Addendum No. 1
 City of Coquitlam
RFP No. 26-037

Cottonwood Tennis Courts - Civil and Landscape Construction Services

Issue Date: March 20, 2026
 Total Page Count: 3

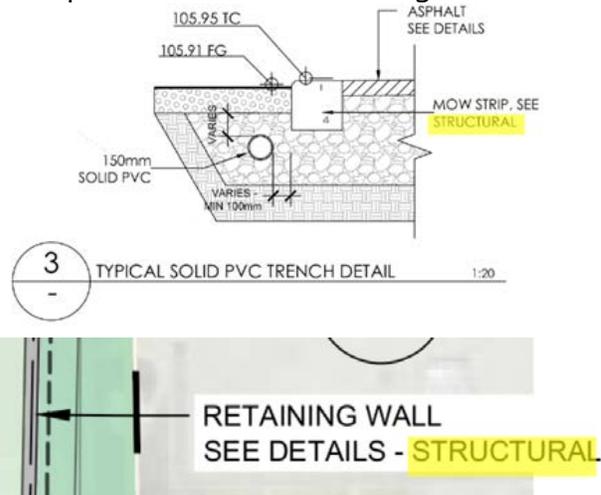
Q3. For the 4 players bench, city supplied and installed by contractor, I don't see there are concrete footing, concrete pads for these items, do you want us to install it on the paved Asphalt?

A3. IFCs will be revised for portable benches: similar product (BL-PB-9) supplied by City but picked-up and assembled by Contractor.
